**SUB-2015-78 & LUC2015-433
380 SOUTH ROAD, DUNEDIN**

Please find the information provided below in support of the application for subdivision and land use consents for the site at 380 South Road which are currently under process by Dunedin City Council.

Fig 1: Foul Sewer Map - The gold oval highlights the 225mm line referred to by Council staff

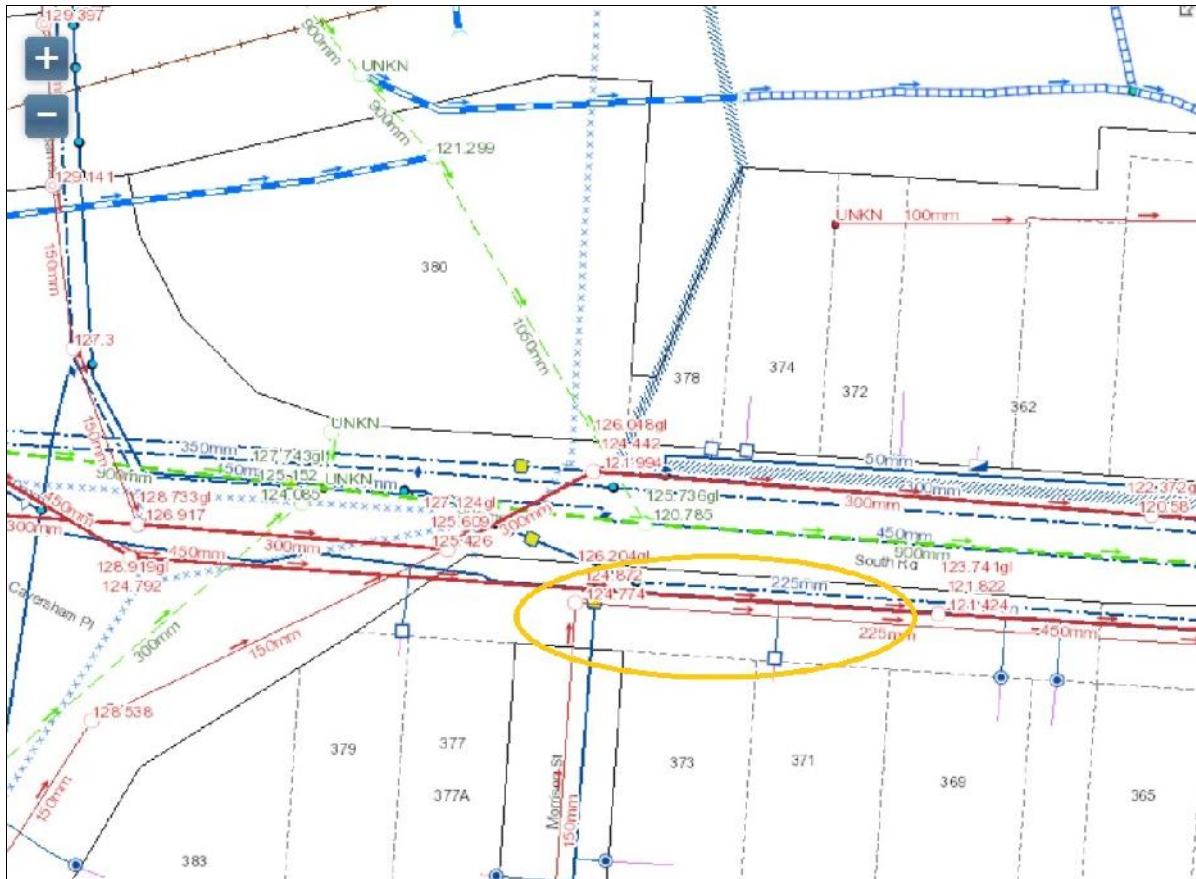
The staff comments from Council's Water and Waste Services department, in relation to the proposed foul sewage reticulation, make two recommendations. Firstly, the comments state that the holding tank, if installed on-site to support sustainable foul sewage discharge, should be designed with a holding period of 24 hours (rather than the 4 hours noted in the application document). Secondly, the comments suggest a preference for the new drainage connection to discharge into the existing 225mm dia foul sewer on the opposite side of South Road due to the existing network being already significantly surcharged.

What is unclear in these comments is whether the options suggested are an either/or scenario (i.e. either connect to the closer main and include a 24 hour period of on-site storage, or connection to the farthest main without needing on-site storage), or whether both requirements are required in tandem.

The second suggestion is for the new drainage connection to discharge into the existing 225mm dia foul sewer on the opposite side of South Road. Staff of Council's Water and Waste Services department note that such a connection would involve a number of crossings with other existing infrastructure, which is correct (the various alignments of existing infrastructure can be seen in the above figure). The new connection will need to be carefully designed to avoid any conflicts with other items of public infrastructure within the South Road corridor. While this might appear to be challenging on first looks, it is not expected to be fundamentally difficult. The depth of the existing foul sewer at the manhole at Morrison Street (1.43m) and the moderate slope of the 225mm dia pipe as it runs east along South Road (approximately 1:15) affords a high degree of flexibility in terms of the design of a new connection to satisfy this request. While some additional real-world information is likely to need to be collected to aid the design of this connection (a sub-surface radar scan, or similar, might be required) we are highly confident that a successful design is indeed achievable.

For a 4 hour storage period we can determine a storage volume of 1,688 litres (270 (litres per person per day) x 3 (peaking factor) x 2.5 (persons per dwelling) x 5 (number of dwellings) x 4/24 (storage period factor) = 1,688 litres). This volume fits within the range suggested in the original application.

For a 24 hour period we can determine a storage volume of 10,125 litres (the same calculation as above but without the 4/24 storage period factor).

Either of these volumes can be feasibly contained on-site. For instance, the greater of the two storage volumes, i.e. 10,125 litres, would be accommodated within an underground chamber made up of 1.8m diameter circular manhole sections installed to a length of 3.98m. There is sufficient open space within the proposed development to enable a chamber of this nature to be installed.

The applicant's preference is to install an on-site storage tank of the required capacity, and to discharge into the closest of the three existing sewers (i.e. the 300mm dia sewer). However, the alternative option, of discharging to the 225mm dia sewer on the opposite side of South Road, is also very likely to be achievable, and similarly, if the two options together were to prove necessary this is expected to be feasible from a physical engineering perspective. Under any of these scenarios, the provision suitable foul sewage discharge can be appropriately implemented.
